09/13/2024  
Lot 9, 65M-

22-016-SITE-GRADING-001-047

Siting and Grading Plan

Trinigroup Development Inc.

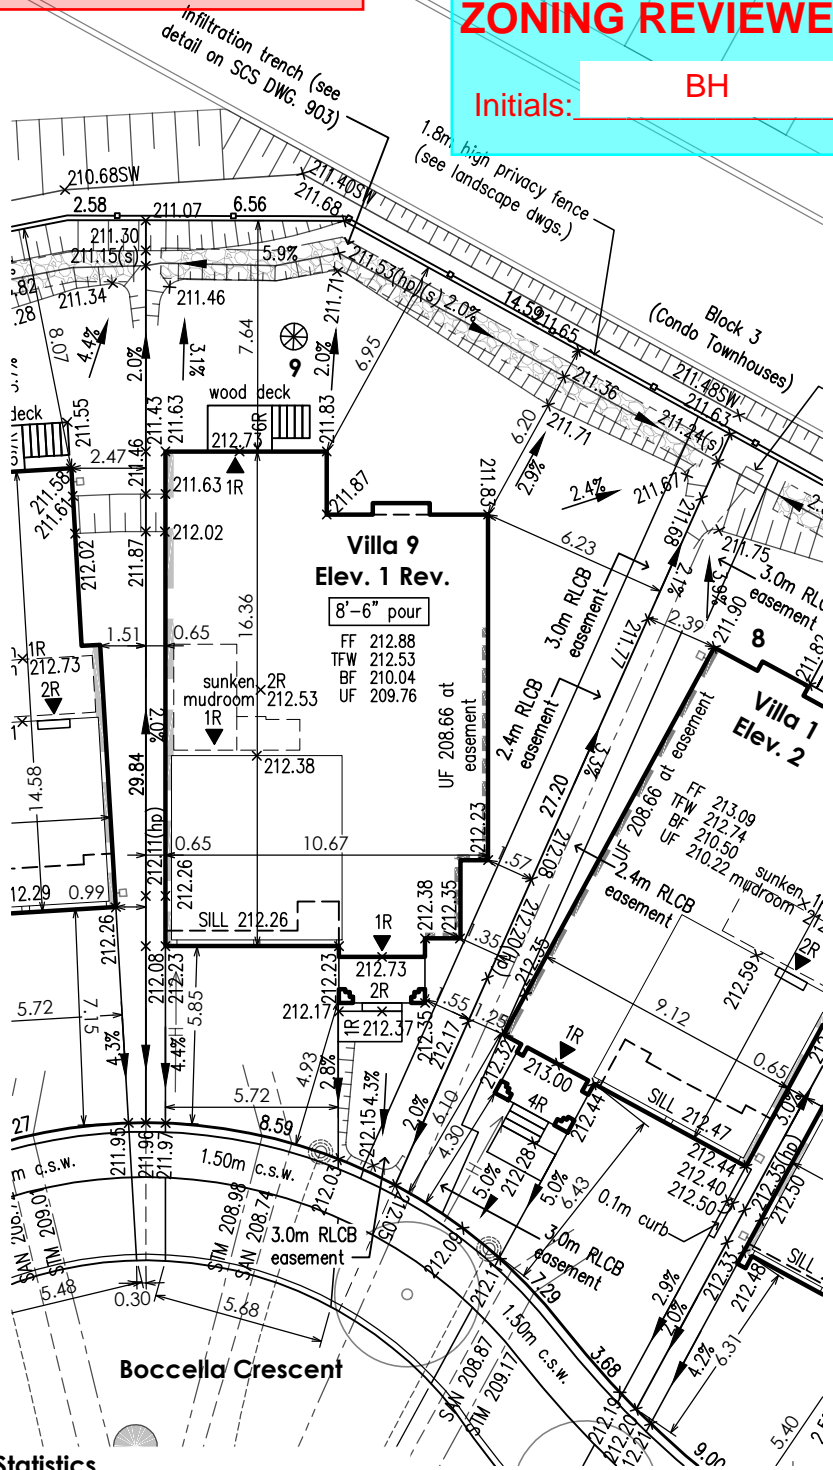
No unprotected openings permitted within 1.2 metres of the lot line as per 9.10.14 of the Ontario Building Code.
